MFN 06-274  
Supplement 1

**Subject: Response to Portion of RAI Letter Number 20 Related to ESBWR Design Certification Application – Seismic Design – RAI Numbers 3.7-16S1, 3.7-24S1, 3.7-30S1, 3.7-33S1, 3.7-35S1, 3.7-38S1, 3.7-39S1, 3.7-50S1, 3.7-54S1 and 3.7-57S1 – Supplement 1**

**Response to Portion of RAI Letter Number 20**

**RAI Numbers 3.7-16S1, 3.7-24S1, 3.7-30S1, 3.7-33S1, 3.7-35S1,  
3.7-38S1, 3.7-39S1, 3.7-50S1, 3.7-54S1 and 3.7-57S1**

Figure 1 RFBF Stick Model

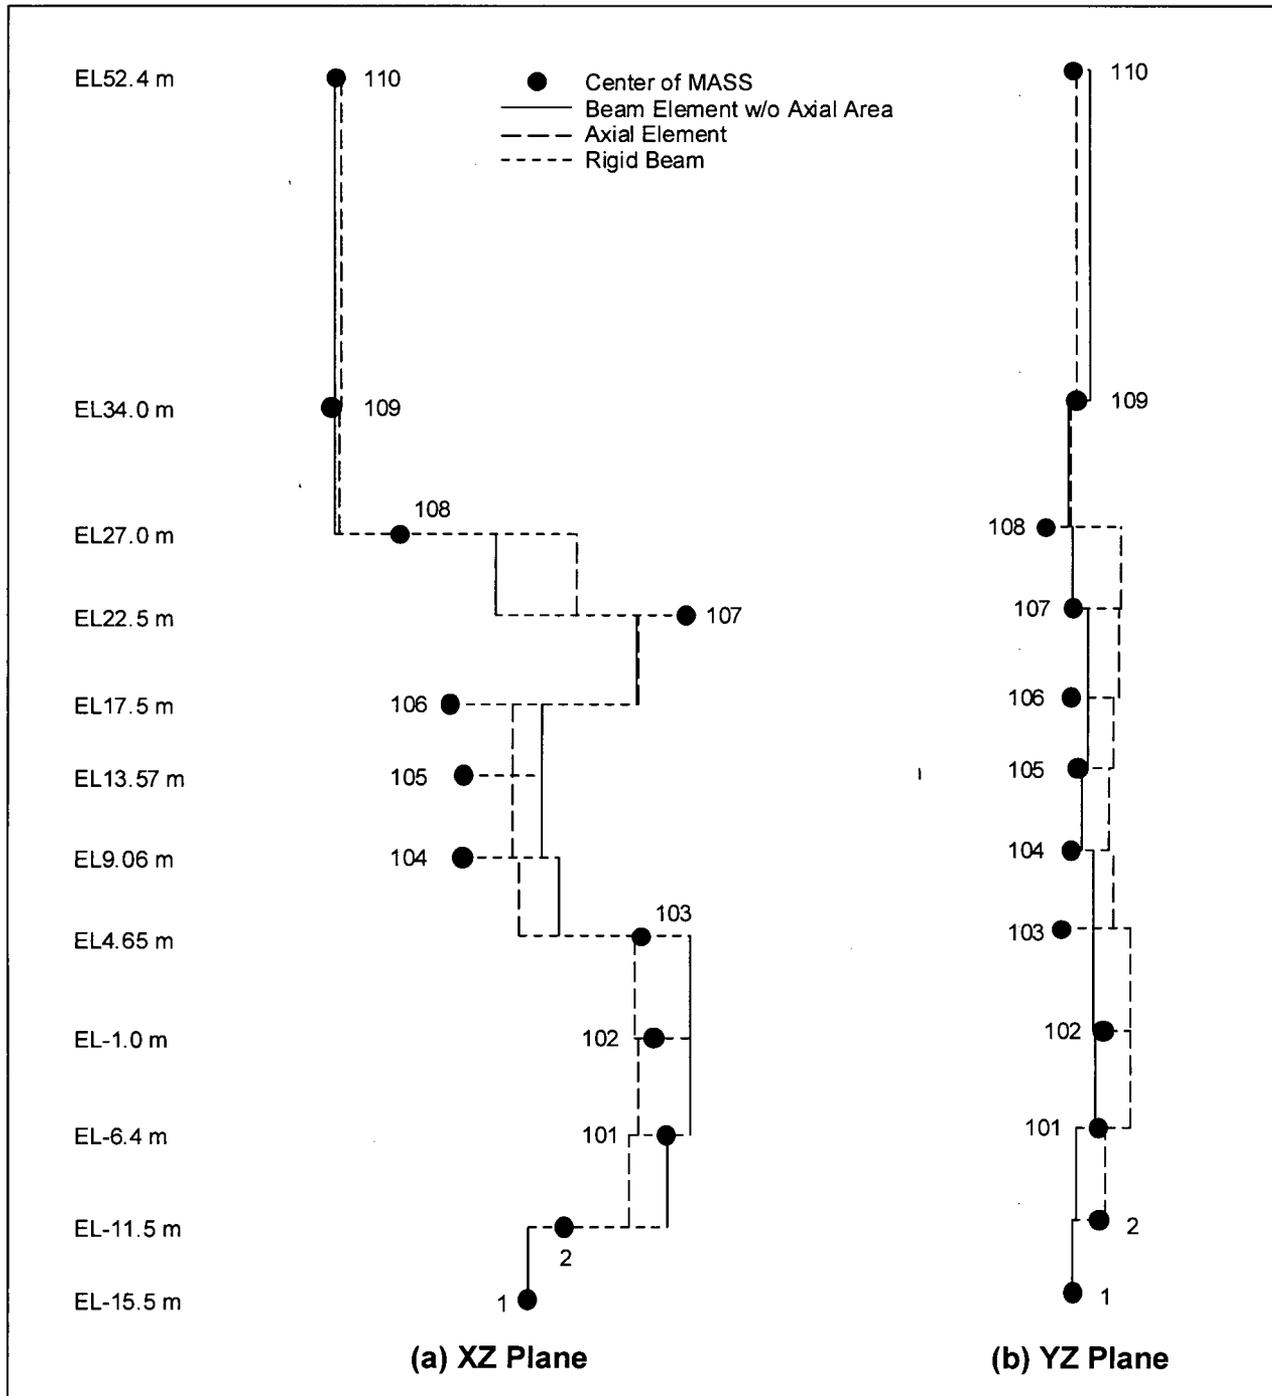
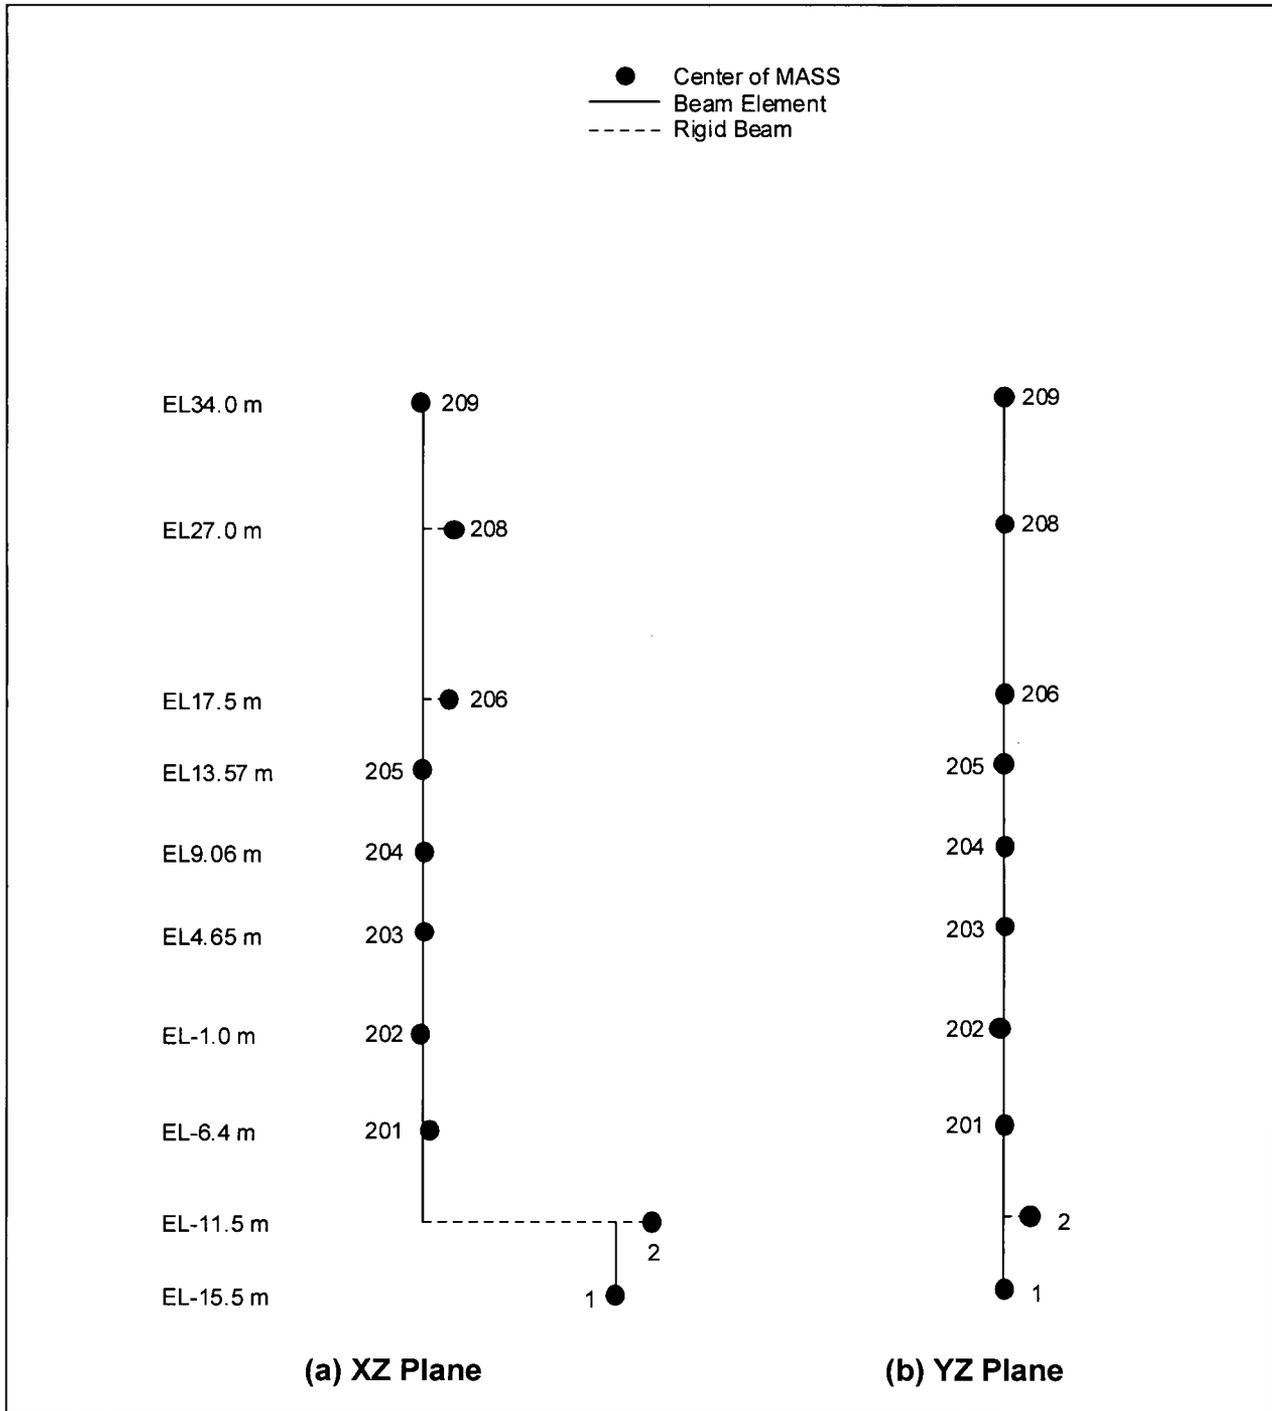
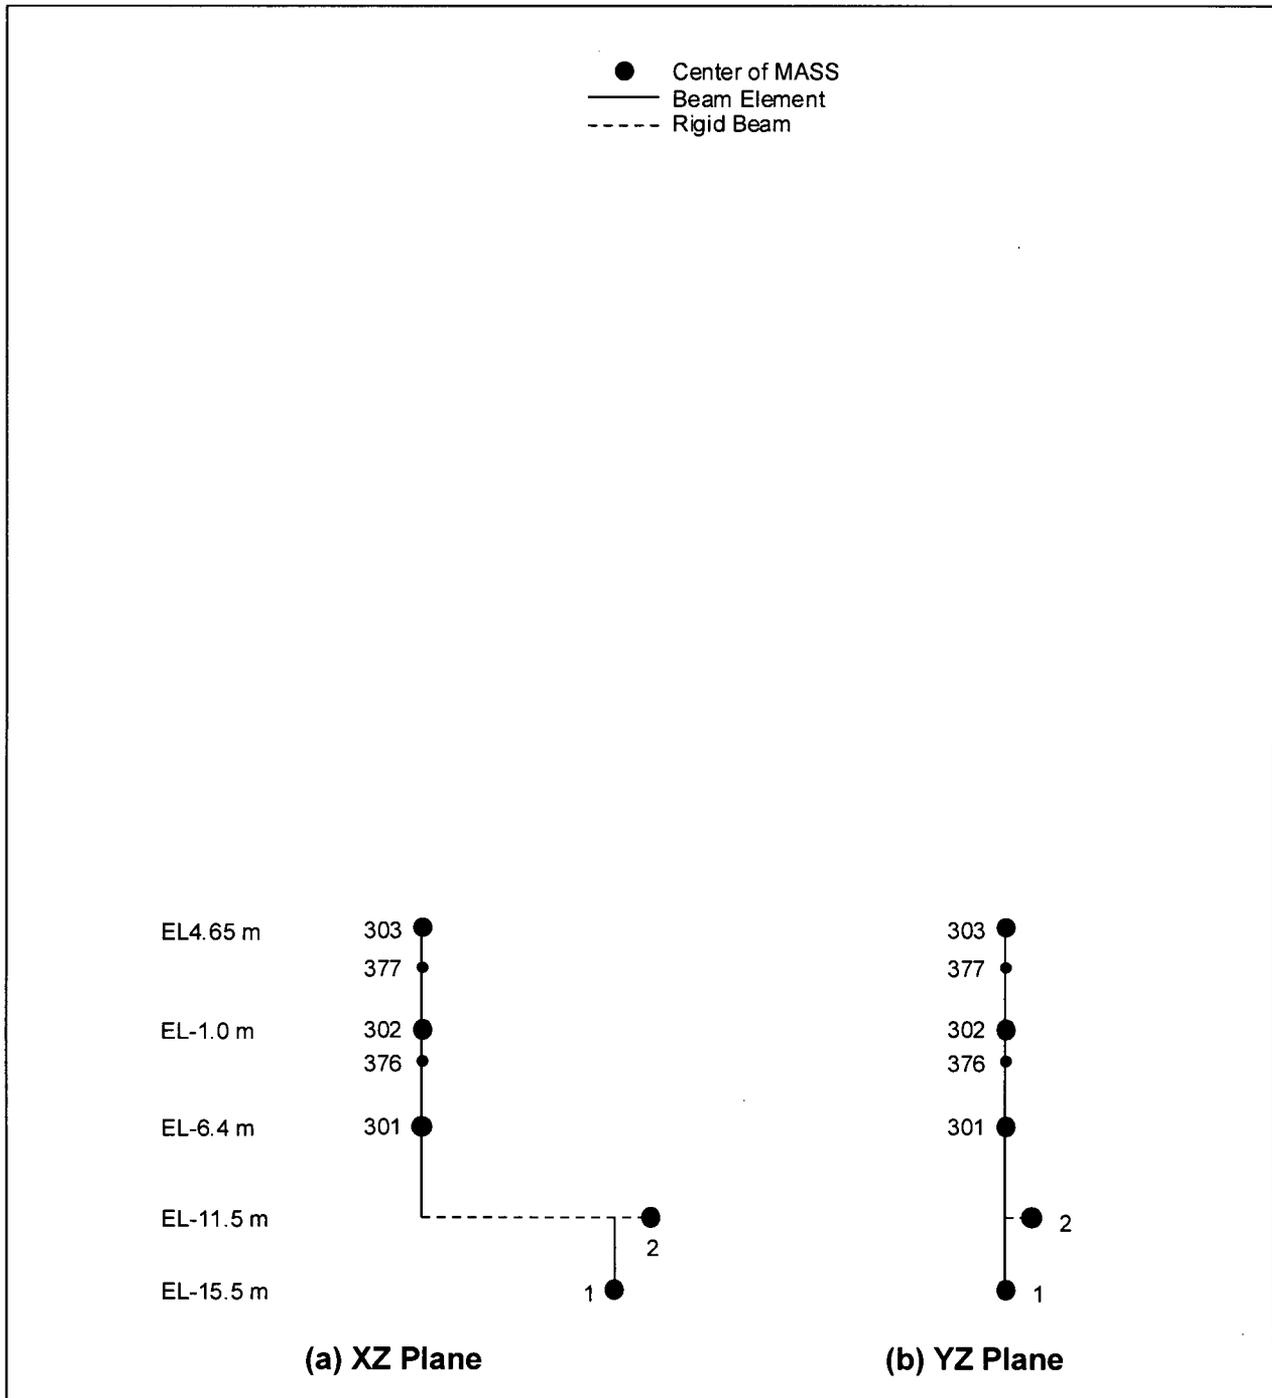
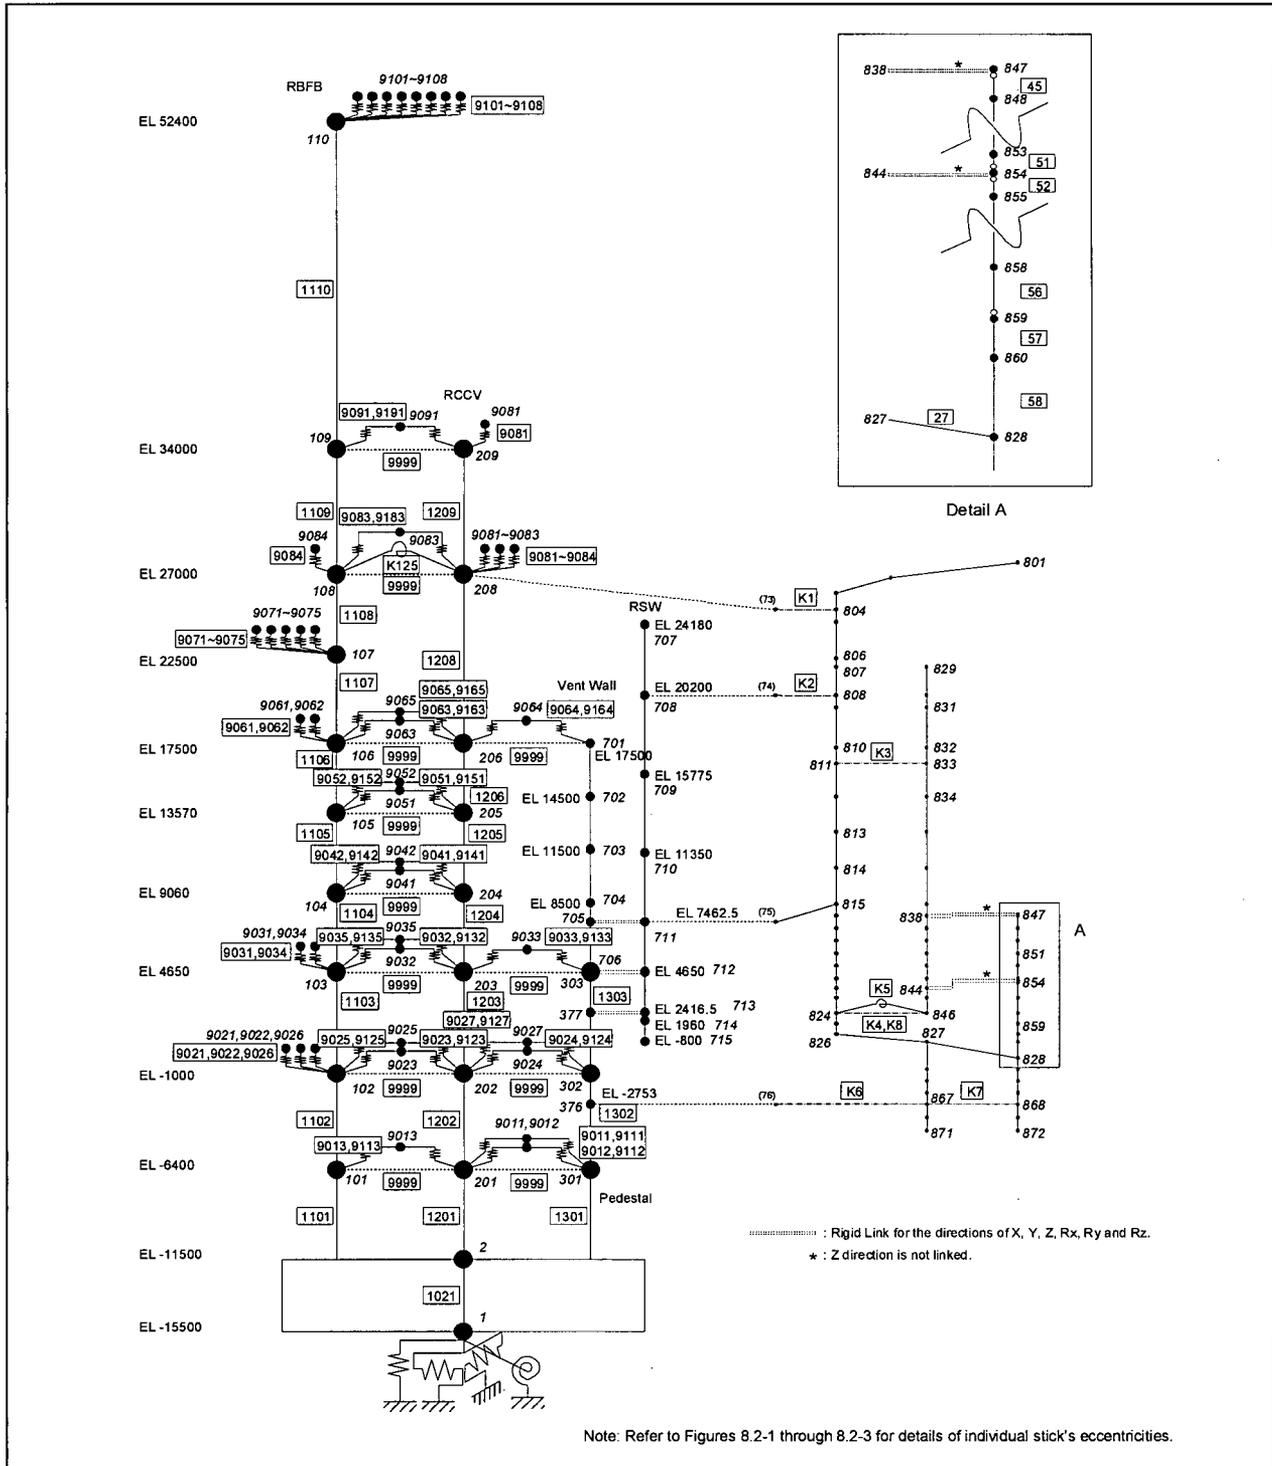
In the NRC audit, the mode shape of mode No. 3, which contains torsional mode, was discussed. The issue was why the Y direction translation of the RBFB node 107 at EL 22.5m is larger than the other adjacent floor nodes.

The RBFB seismic stick model is a 3-D model considering the building eccentricity as shown in Figures 1 through 4 in Attachment SER-ESB-054. The RBFB node 107 at EL 22.5m is located south of the other adjacent floor nodes, because of the FB roof weight. Therefore, if a torsional mode is predominant in mode No. 3, Y direction translation of this floor becomes larger than those of the other floors.
